U.S. Department of the Interior
BUREAU OF LAND MANAGEMENT

Well Name: WEST FORK

Type of Action: Plug and Abandonment

Conditions of Approval to Notice of Intention to Plug and Abandon

West Fork #1**Proposed P&A****Basin Fruitland Coal / Gallegos Gallup****940' FNL & 1560' FWL, Section 14, T26N, R12W, San Juan County, NM****API: 30-045-25632**

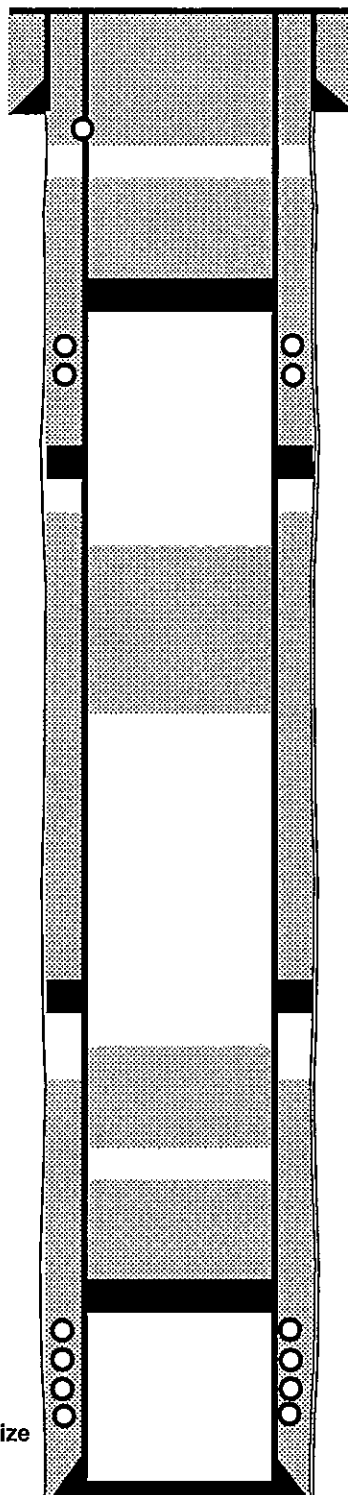
- a. Adjust Plug #2 (Mancos) to cover BLM formation top pick @ 4005' (Minimum 3915' - 4055'). Current plan of 15 sxs Class G Neat is sufficient.
 - b. Add plug to cover BLM Kirtland formation top pick @ 475' (Minimum 10 sxs Class G Neat covering 425' - 525')

- c. Adjust #5 (Surface) to cover Ojo Alamo top @ 270' (Minimum Surface - 320' Inside/Outside).
3. **NOTIFICATION:** Farmington Office is to be notified at least 24 hours before the plugging operations commence at (505) 564-7750.

- Gallup perfs 5083' - 5278'. Fruitland coal perfs 1382' - 1398'.	1) Formation Tops Same
- Adjust Plug #2 (Mancos) to cover BLM formation top pick @ 4005'.	
- Adjust Plug #3 (Cliff House) to cover BLM formation top pick @ 2240'.	
- Adjust Plug #5 (Surface) to cover the Ojo Alamo top @ 270' and Kirtland top @ 475'.

Created By	Condition	Condition Date
john.harrison	Please add additional plug or cmt to cover DV tool.	7/31/2023
